## ZONING COMMITTEE STAFF REPORT

**FILE NAME:** 1346 Arcade St. LLC

**FILE #** 20-096-344

**TYPE OF APPLICATION:** Nonconforming Use Permit (Change & Expansion), Variance

# SITE PLAN

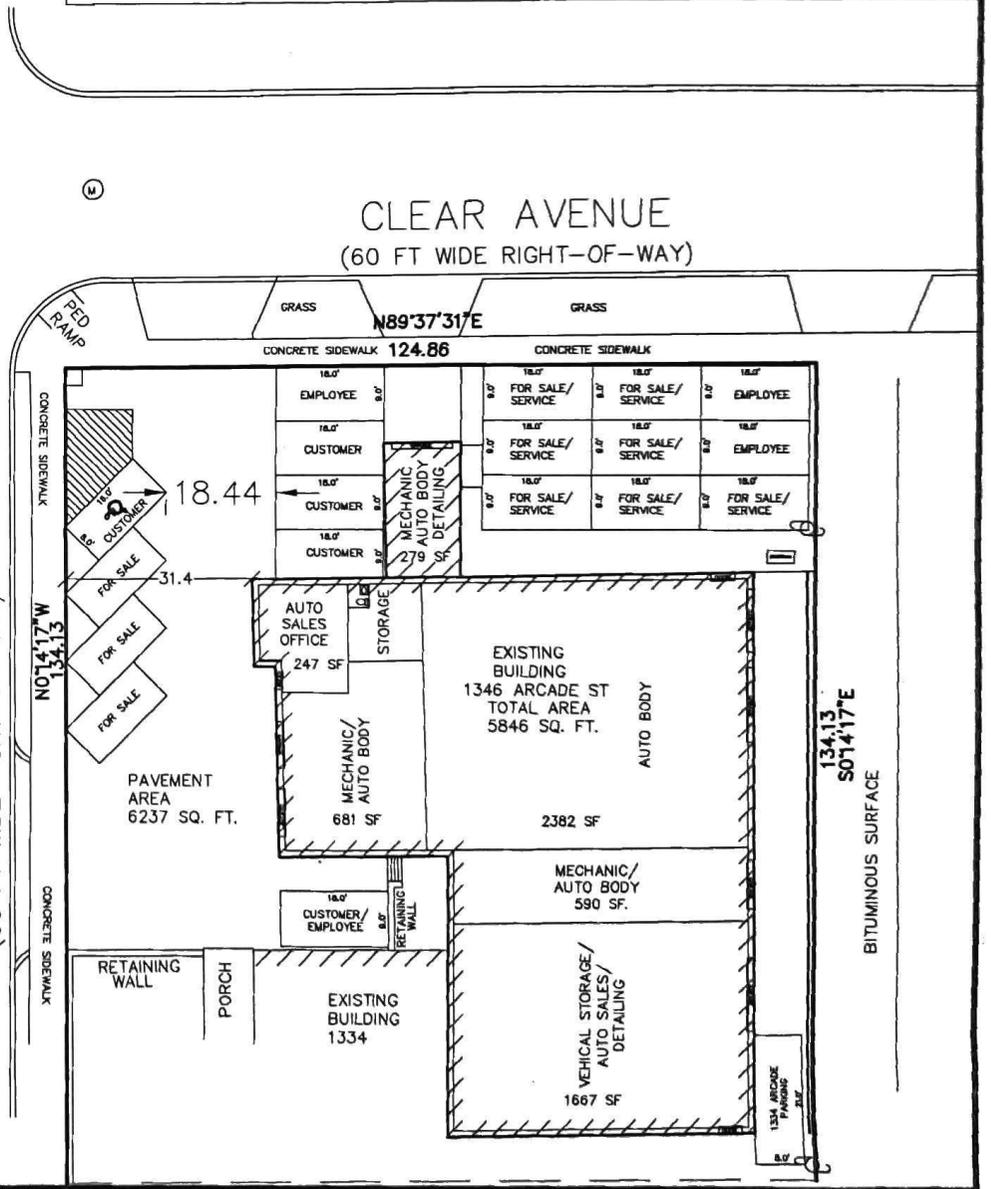
With about 34 feet at most between the existing building and public sidewalks along Arcade Street and Clear Avenue, there is only enough room for a one-way drive aisle and angled parking along the north and west sides of the building. The most efficient way to provide parking with this layout would likely be with a curb cut on Clear Avenue that meets the requirement for at least 60 feet of separation from the Arcade-Clear intersection, and the existing exit to Arcade. The existing curb cut close to the corner would just get in the way of having additional parking spaces there. It appears that 14-15 off-street parking spaces could be provided in this area without overhanging or maneuvering on the public sidewalks.

The application materials include photographs that appear to call into question the ability for a tow truck to maneuver through the site without using the curb cut on Clear closest to Arcade. However, any difficulty making this maneuver would be alleviated by elimination of the spray booth addition.

2. The spray booth addition on the north side of the building shall be removed.
  3. The Clear Avenue curb cuts within 60 feet of the Arcade-Clear intersection shall be removed and replaced with curbing.

4. Off-street parking on the site shall meet dimensional and design standards in the Zoning Code to the greatest extent possible, including the perimeter and screening landscape requirements in Zoning Code § 63.314 for parking facilities and outdoor auto sales adjoining public streets or sidewalks.

Current Site Plan / Proposed Site Plan  
Driving Lane

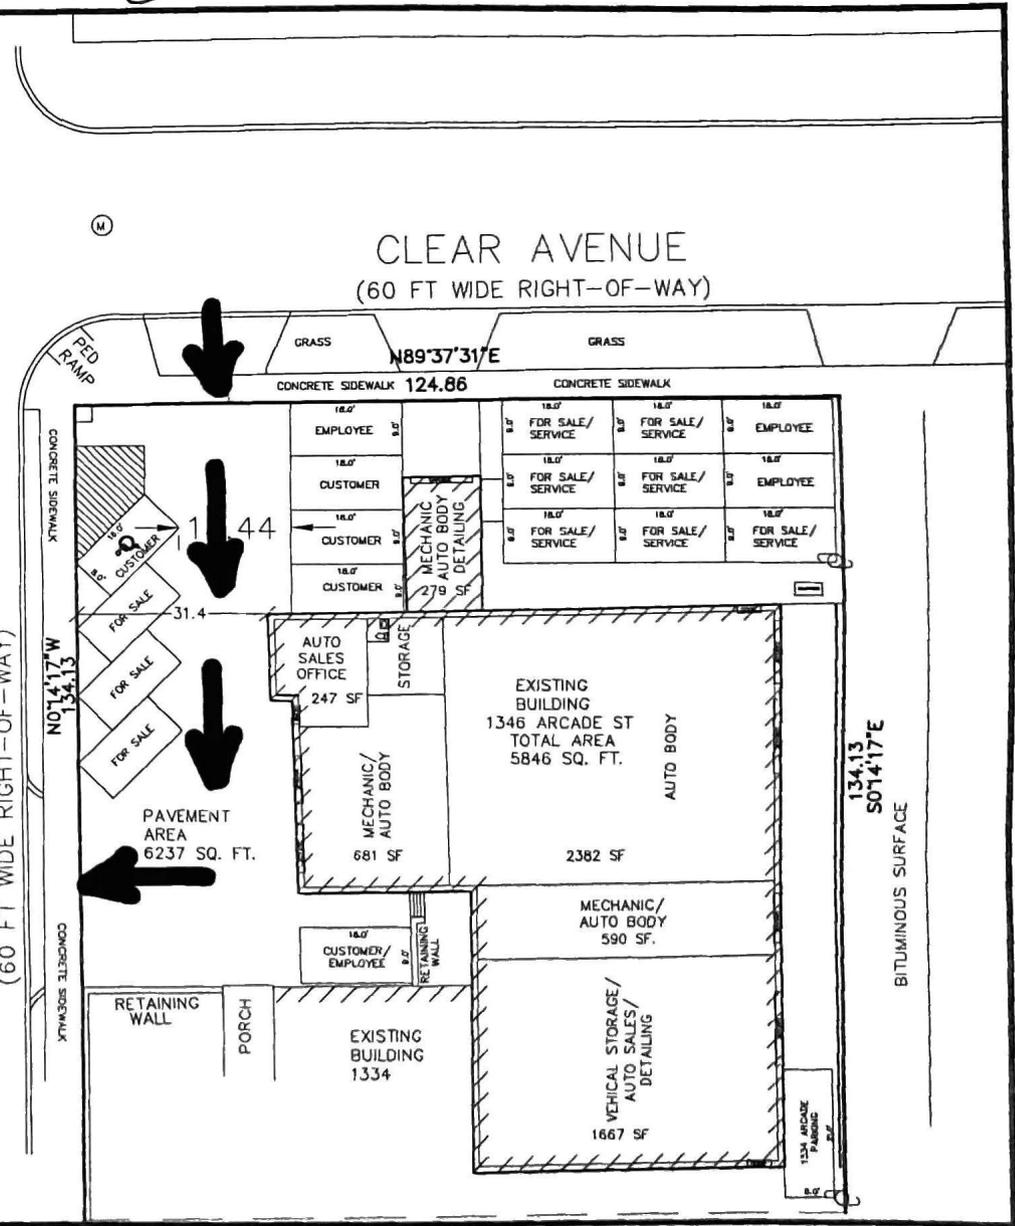
Staff report maybe was under the assumption/impression that this vehicle bay was used for painting vehicles and it is not. This bay has not been used as a spray booth since the 1990's and has been a vehicle bay for the past 30+ years. There are no spray booth equipment or exhaust in this bay it is a simple bay but very necessary to our operation currently we are using this bay to clean and prep vehicle to give back to customer and this operation can not be done in the other areas of the business. By removing this bay we would also lose 4 off-street parking spaces just west of the bay. We would like to maximize our site plan to provide as many off-street parking spaces as possible.

We would ask the Zoning Committee to approve the 60 feet entrance variance to add an Outdoor Auto Sales License. This requirement is not needed for auto body or auto repair it is only required for auto sales (not sure why). We have 2 entrances to our business and only 1 is less then 60ft. Changing the entrance to our business would be a unnecessary hardship and problematic to our business/operation. This has been the same entrance for many years and works well. It allows the vehicles to come in and out and maneuver with ease. Occasionally there are large tow trucks and vehicle part delivery trucks (see attached pictures) that come to our shop and getting in and out with ease is necessary. Neighbor's support this as well as they like the idea of tow trucks dropping off vehicles on our property versus in the middle of the street blocking traffic. Eliminating this entrance would create a problem for maneuvering in and out of the parking lot. Also by changing the location of the entrance we would lose a minimum 4 off-street parking spaces.

We are asking to remove only the requirement for landscaping as there is no room we would lose all of our parking spaces facing Arcade. Landscaping is only required for auto repair and is not required for auto sales or even the current auto body license. Keeping a good image and good curb appeal is always top priority, we have taken advantage of doing landscaping in between the sidewalk and street on arcade. We always want to have a clean crisp image to our neighborhood. We have owned the building for over a year now and have made many improvements and will be continuing to do so.

1. The garage addition behind the house at 1334 Arcade labeled "1667 SF" shall only be used for vehicle storage, auto sales storage and vehicle detailing. No auto body or auto repair shop work to be done in this area.
2. Remove Condition 2; because it is not a spray booth and would be problematic for our business.
3. Remove Condition 3; To grant variance distance to corner is less the 60FT; problematic for our business / Practical difficulty.
4. Remove Condition 4; unnecessary hardship, there is no physical room for extra landscaping and would lose necessary off street parking. The landscaping requirement is not needed for outdoor auto sales it is only need for auto repair. Current non-conforming site plan with landscaping requirement variance has already been approved by city for the current body shop license.
5. Agreed
6. Agreed
7. Agreed
8. Agreed
